DOCUMENT CHANGE REQUEST

DCR number 246	Changes required for: N/A	Originator: Ron Fidler
Date: 2006/03/17	Date sent: 2006/03/17	Organisation: ESA/ESTEC
Status: IMPLEMENTED

Title:	Transistors Low Power NPN, based on type 2N2369A		
Number:	5201/006	Issue:	1

1.6.1 Metal Can Package (TO-18) - 3 lead

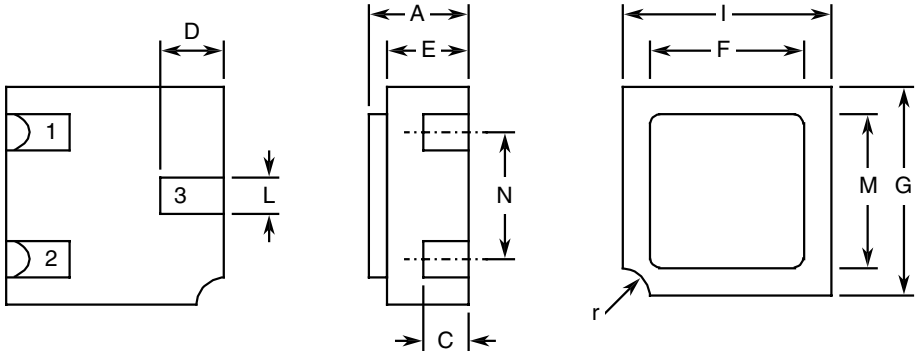
6. Figure 2(a) - Dimensions e, e1 and a corrected from "TYP" to "BSC"

VOLTAGE WAVEFORMS

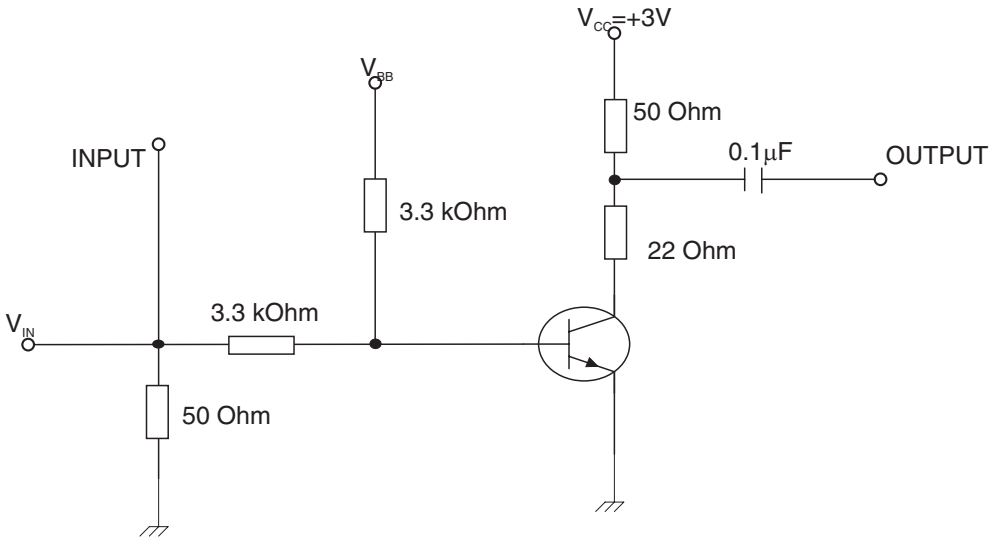
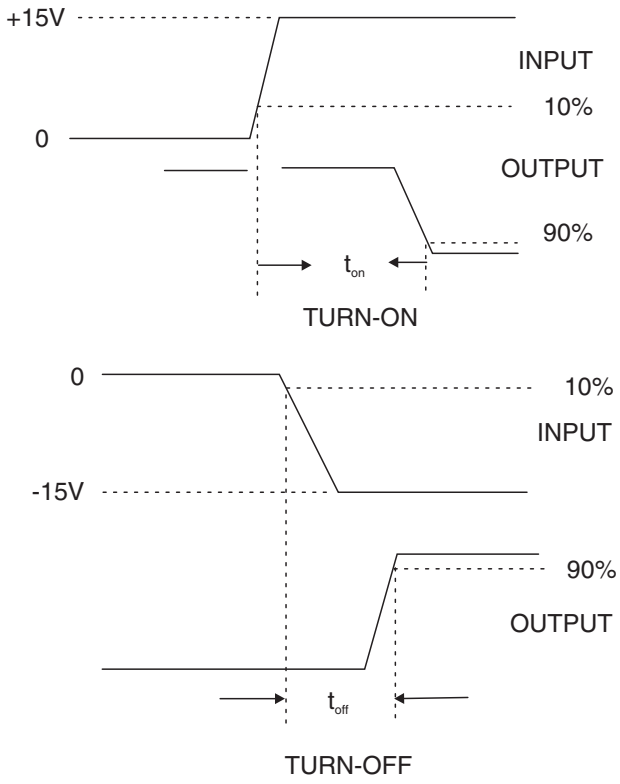
15. Table 2 and Figure 4 - MIL test method deleted from tON and tOFF and a new Note 3 added which fully defines the tests based upon the actual test circuit and conditions used by STM and shows this test circuit and the waveforms.

7. To add the correct version of the test circuit and conditions used by STM for tON and tOFF tests.
